FORD - NEW HOLLAND - VERSATILE

SERVICE JOURNAL

Issue 11-12/93

FIGURE 1

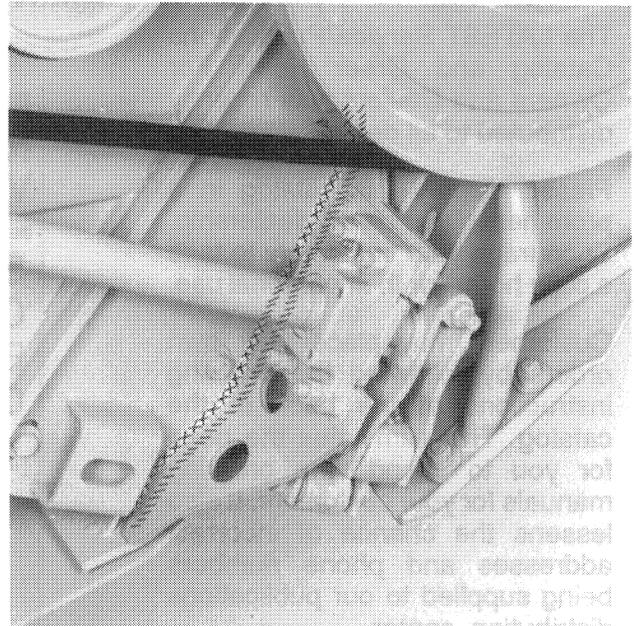
Missing or poor penetration of the weld on the right side of the header frame around the support for the yoke shaft bearing.

Check the right side of the headers for poor weld penetration and missing welds. There should be a continuous 3/8" bead of weld around the entire support, as shown in Figure 1. If incorrect, grind away existing weld, which has not penetrated, and reweld.

FIGURE 1

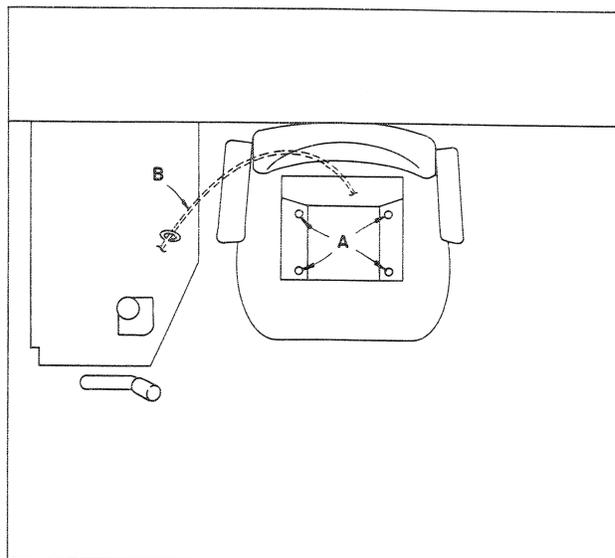
Units with mechanical spring suspension can be upgraded to the air ride seat by installing the following parts:

The support for the air ride seat will mount to the existing four holes, A, as shown in Figure 1. Route wire harness, B, from behind the seat, across the floor to the console at the right of the seat, as shown in Figure 1.

FIGURE 1

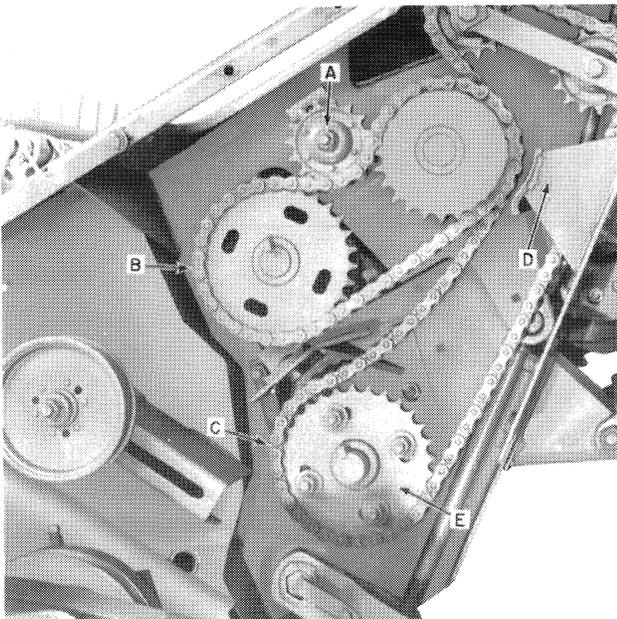
Improper chain tension on the conditioner roll drive sprockets can lead to conditioner roll stub shaft and/or bearing failure.

2. Measure the chain deflection in the center of the longest span.
3. Loosen idler bracket, A, Figure 1, and adjust upper roll drive chain, B, to 1/8" - 1/4" (3.2 - 6.3 mm). Retighten the idler hardware.
4. Adjust lower roll drive chain, C, to deflect 1/2" (12.7 mm) in the center of the longest span. Loosen bolt, A, Figure 2, and adjust eyebolt, B, until the chain tension is correct. Retighten the adjuster hardware.

FIGURE 1

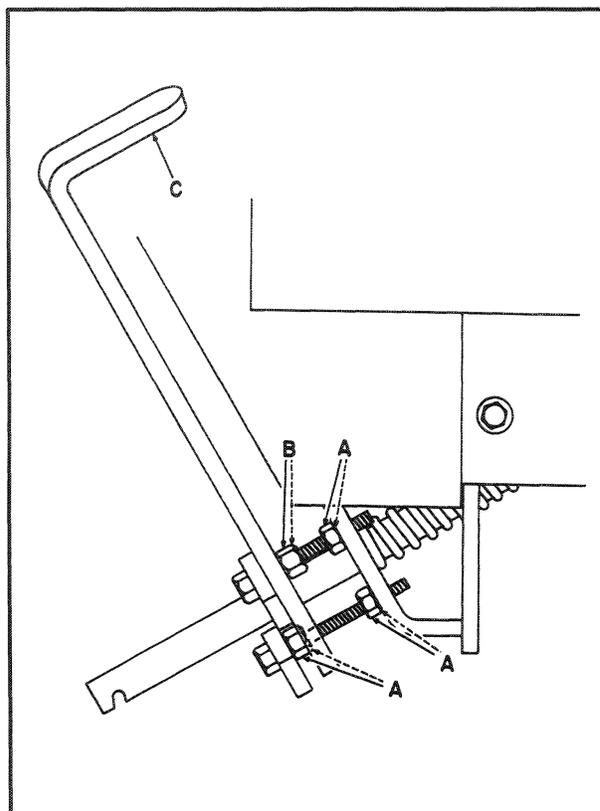
1. Extension side shields may crack around the mounting pin hole.
2. Replacement shields will not mount to the extension table.

The table latch must be assembled correctly to keep table bounce to a minimum. Jam nuts must be used at A, Figure 1, and locknuts at B, against the latch handle.

FIGURE 1

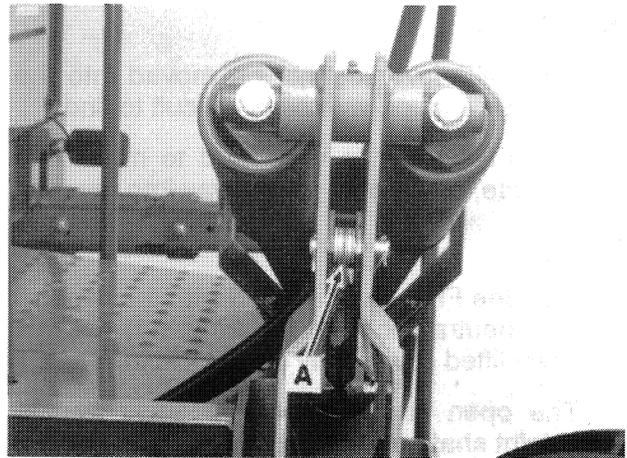
The cylinder rod bends or breaks.

A #9845802 bracket weld assembly is attached to the bell crank and the front of the optional float spring. Remove the pin retaining the front of this bracket to the bell crank. Spread the bracket apart as far as possible and install five #80299 flat washers, A, Figure 1, between the two sides of the bracket. Reinstall the pin and secure it with a new cotter pin. Do this on both sides.

FIGURE 1

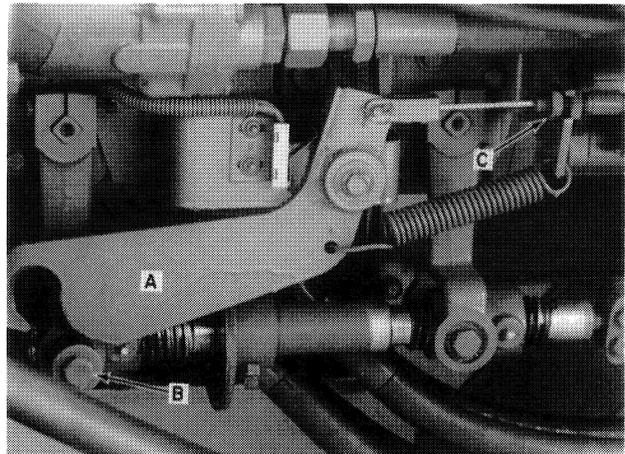
1. The FNR lever cannot be moved into the reverse slot, or reverse is difficult to find.
2. The FNR lever is very hard to move into reverse, or will only go partway into reverse.

1. With the FNR lever aligned with the reverse slot, neutral lock arm, A, Figure 1, has not been lifted completely off of lockpin, B.
2. The open end of the telescoping double U-joint shaft, under the cab, is up and full of dirt, not allowing it to slide together.

1. Adjust the neutral cable at C, Figure 1, so there is no interference between bracket, A, and pin, B, when the FNR lever is at the reverse slot.

FIGURE 1

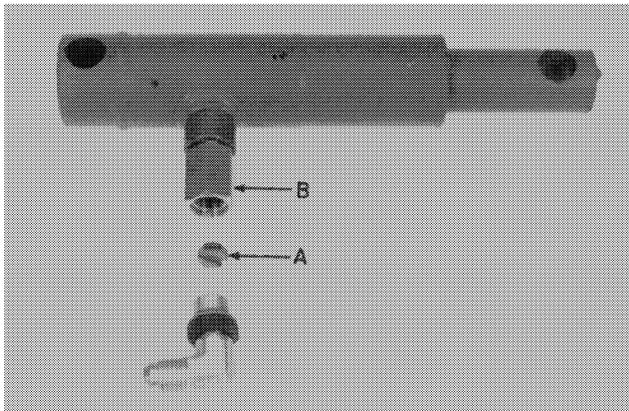
The pickup raises abruptly or too fast on units equipped with the optional hydraulic lift kit.

During assembly, a 0.032" orifice, part #261066, must be installed in the adapter fitting at the cylinder port. The orifice must have the slot facing away from the lift cylinder to restrict the oil flow. If orifice, A, Figure 1, has been installed correctly and the pickup continues to raise too fast, the orifice may have jammed or flipped over inside the adaptor fitting, B. Measure the depth of

FIGURE 1

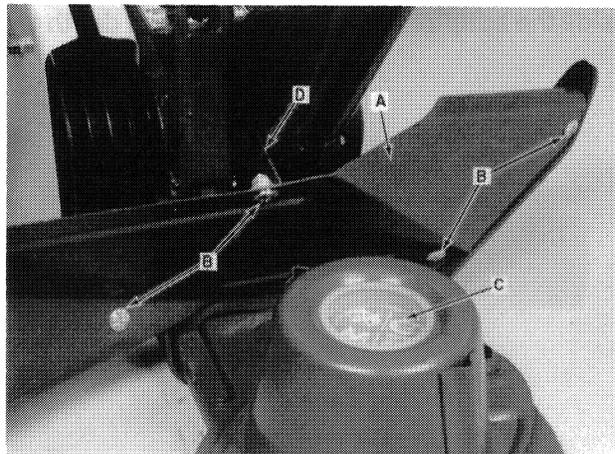
Left-end cone knives interfere with the inner swathboard.

1. Incorrect assembly of the inner swathboard, A, Figure 1.
2. An elevated end cone is used to reduce knife contact during operation.

1. Rotate the inside disc to check for clearance between the knife tip and swathboard. Loosen the hardware and force the swathboard upwards to clear the knives and then retighten the hardware. If the knives still do not clear, modify the swathboard by cutting a notch in the bottom, as shown in Figure 2. Replacement swathboards, part #274108, are notched to alleviate knife interference.
2. Notched swathboards were installed in production on Models 442 to 463 above serial #930001 and Model 465 above serial #920001.

To ease the installation of the inner swathboard, the round headed hardware, B, Figure 1, has been replaced by carriage bolts. Also, bracket, D, is welded to the cover support frame on units above serial #930001.

FIGURE 1

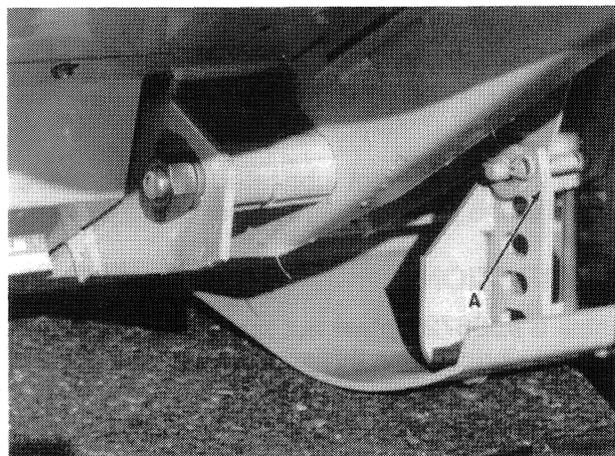
Skid shoes cannot be positioned to the lowest cutting height position because of interference with the frame.

Grind or cut away the corner of the bracket, part #9804197, as shown at A, Figure 1.

FIGURE 1

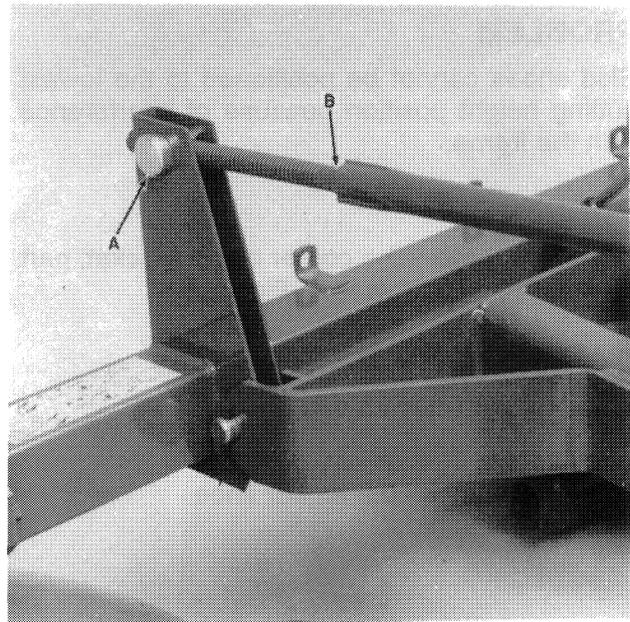
Rotor tilt is difficult to adjust.

Crank threads are not lubricated and may have seized to the pivot nut, A, Figure 1.

Install a #556725 pivot nut and #87414 grease fitting. Lubricate the threads, as required. Units above serial #821807 have the pivot nut and grease fitting assembly factory installed.

FIGURE 1

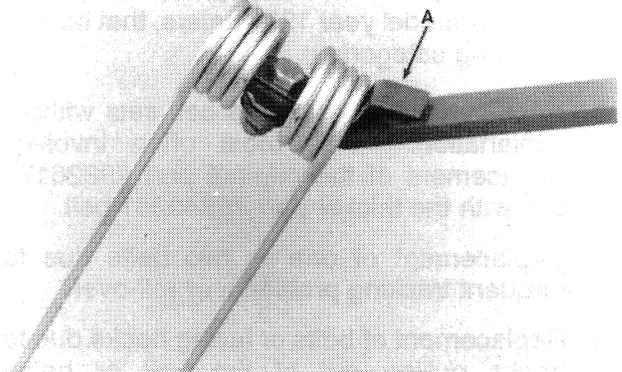
Crop wraps around tine arm coil spring.

Install a #9805629 deflector on each tine arm, A, Figure 1. Torque the tine hardware to 118 ft. lbs. (160 N·m). Advise customers to check the bolt torque after the first several hours of use.
